**CITY OF SNELLVILLE  
DEPARTMENT OF PLANNING & DEVELOPMENT  
MAYOR AND COUNCIL**

**CASE SUMMARY**

**CASE NUMBER:** #RZ 25-01

**DEVELOPMENT/PROJECT:** 65-Unit Single-family (Attached) Townhome  
Development

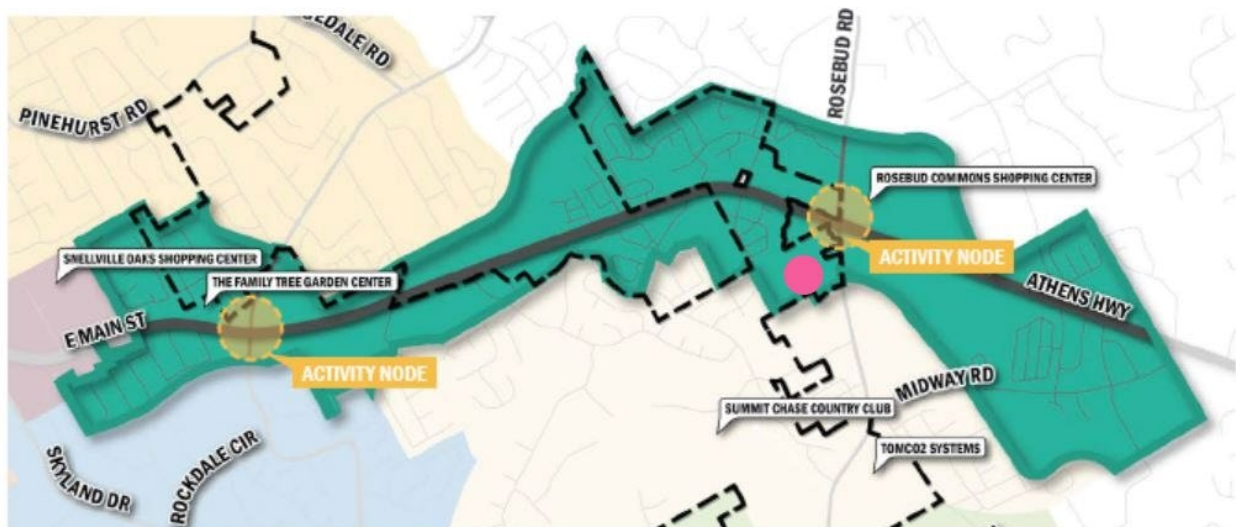
The conceptual rezoning site plan, dated 12-09-2024 (below) shows the general layout of the 65-unit townhome development with eleven (11) rear-entry townhome buildings and a single six-unit front-entry townhome building (Lots 14-19) with vehicular circulation provided by a 27-foot wide (back-of-curb) public/private road, 19-foot wide connectors and 16-foot wide one-way alleys.

A proposed 2,500 sq. ft. community clubhouse with greenspace, mailbox kiosk and thirteen (13) parking spaces is located at the beginning of the development at the shared full-access driveway on Rosebud Road. This driveway is shown to also serve as a secondary ingress/egress point for the adjacent mixed-use development to the north. Pedestrian circulation is provided by a 5-foot wide sidewalk with 2.5-foot planter adjacent to the internal public/private road.

Two (2) stormwater management ponds serving the development are located on the western portion of the site with over nine (9) acres of the total site (53%) undeveloped and provided as open space, mostly due to the unbuildable site area located within the Big Haynes Creek special stream buffer area.

The minimum required number of parking spaces is one (1) space per townhome unit plus one (1) space per (4) units which equates to 82 total spaces. The conceptual zoning plan shows 260 total spaces (assuming two (2) vehicle parking within each 2-car garage plus two (2) vehicle parking on the 17-foot wide by 22-foot long driveways) or 130 total spaces with no vehicle parking in the townhome garages. Unless prohibited by the Homeowner's Association, additional guest and visitor parallel parking could be provided in the street.

Variance Analysis: The rezoning site plan shows what appears to be a 2.5-foot wide planter strip between the 5-foot wide sidewalk and street roll-back curbing (see Variance #2). Therefore, no variance is required except to reduce the 5-foot wide planter requirement to 2.5-feet (see Variance #3).

Variance Analysis: Because of the 24-foot narrow townhome width and 17-foot driveway width on Lots 14-19, roll-back curbing is appropriate due to the limited space between each driveway apron; therefore, making the transition between the driveway apron and vertical curbing difficult and ineffective.

Variance Analysis: For streets categorized as *Local Street –Residential (Urban)*, the minimum required roadway pavement width is 27-feet excluding concrete curb and gutter which typically measures 1.5-feet wide, per side. Combined, with the 27-foot pavement width and 3-feet of curb and gutter on both sides of the roadway, the code requirement is 30-feet, measured back-of-curb. This 3-feet of additional street width allows for a safer environment for the passage of two vehicles at points where there is on-street parking.

Variance Analysis: In consideration with the denial recommendation for the reduced street width in Variance #3 above, the 2.5-foot planter width reduction is consistent with other townhome developments in the city and still allows the planting of under-story street trees with a reduced canopy width in the planting area between the townhome buildings and sidewalk.

Recommendation: No variance is required.

Recommendation: The Planning Department recommends *approval*.

Recommendation: The Planning Department recommends *denial*.

Recommendation: The Planning Department recommends *approval*.
